Reference: W382-62F01(rev0)- WE Letter

RE: LEVEL 09 COMMUNAL ROOF GARDENS, TOWERS E AND D, BENNELONG PARKWAY, WENTWORTH POINT PEDESTRIAN WIND ENVIRONMENT LETTER

This letter is an addendum to the Pedestrian Wind Environment Statement (W382-61F03(rev0)- WS Report), which was issued on the 25th of March, 2020, which assessed the impact to the local wind environment of Towers C and F of the Bennelong Parkway Development in Wentworth Point.

Figure 1 – Suggested Treatments for the Communal Roof Gardens

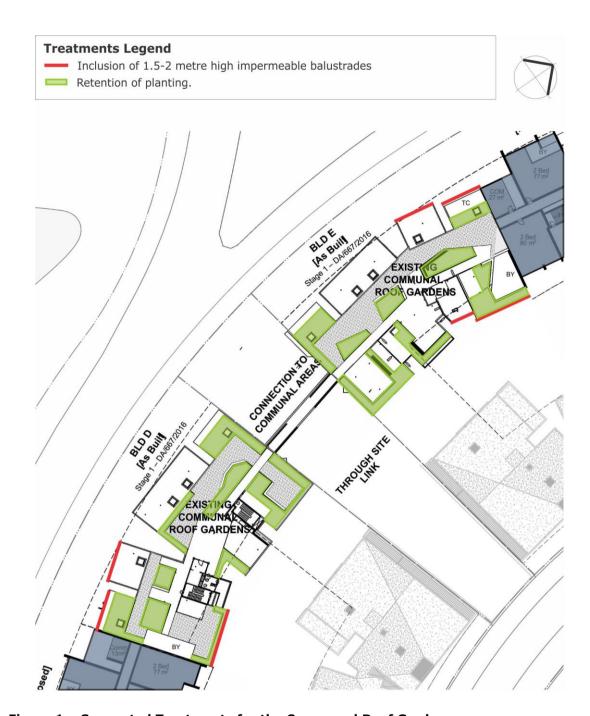
The Communal Roof Gardens on the roof of Tower D are exposed to north-easterly winds upwashing and accelerating around the north-western corner of Tower C, westerly winds upwashing and accelerating around the north-eastern corner of Tower C, and south-easterly sector winds upwashing and accelerating around the north-eastern corner of Tower C.

The Communal Gardens on the roof of Tower E are subject to north-easterly winds upwashing and accelerating around the south-eastern corner of Tower F, westerly winds upwashing and south-easterly sector winds upwashing and accelerating around the south-western corner of Tower F.

The presence of Towers C and F is expected to introduce corner accelerating winds to the Level 09 Communal Roof Gardens. The bridge between the two abovementioned gardens is not expected to be significantly impacted by the presence of Towers C and F.

To mitigate the abovementioned effects, it is recommended to include 1.5-2 metre high impermeable screens at the southern end of the Tower D garden and at the northern end of the Tower E garden to shield the space, as shown in Figure 1. It is also recommend to retain the proposed planting throughout the gardens, as shown in Figure 1.
